# North Hertfordshire District Council

## Building Conservation comments

**File Ref:** 24/01729/FPH & 24/01730/LBC

**Subject:** Raise existing chimney stack.

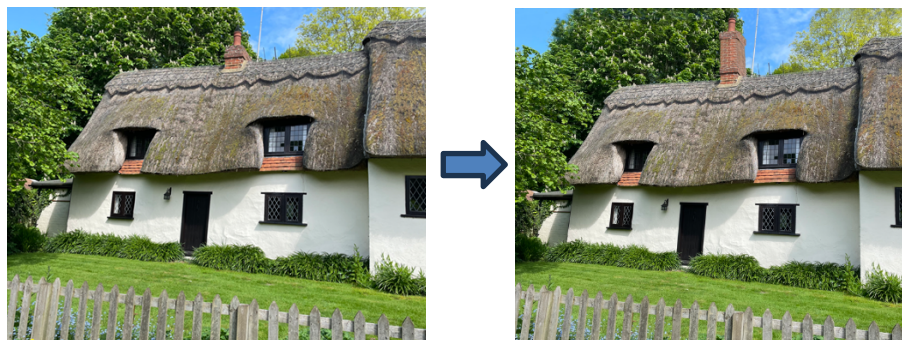
*The project is to raise the central chimney stack in matching red brickwork pointed in*

*hydraulic lime mortar, using a gritty aggregate to match the existing. The existing stack will be taken down to the oversailing or corbelling courses after careful removal of the chimney pot. The stack will be raised in matching handmade red brick so that there is 1800mm above the ridge. The existing chimney pot will then be re-fixed.*

*The chimney will be lined internally with a twin walled stainless steel liner to be able to be fit a wood burner in the existing open hearth beneath. It is now an insurance requirement for either open fires or wood burners to have a chimney stack which extends at least 1800mm above the ridge line to prevent fires.*

1. Standard LBC time condition.
2. The existing stack shall be dismantled to the oversailing course and no lower unless the oversailing course itself also requires removal in which case this shall be reinstated in the rebuild as per the existing detail.

3. Details or sample of the brick type used to increase the height of the stack shall be submitted to and approved in writing by the Local Planning Authority prior to the commencement of the development hereby

consented. Thereafter, the stack shall be constructed in accordance with the approved brick type.
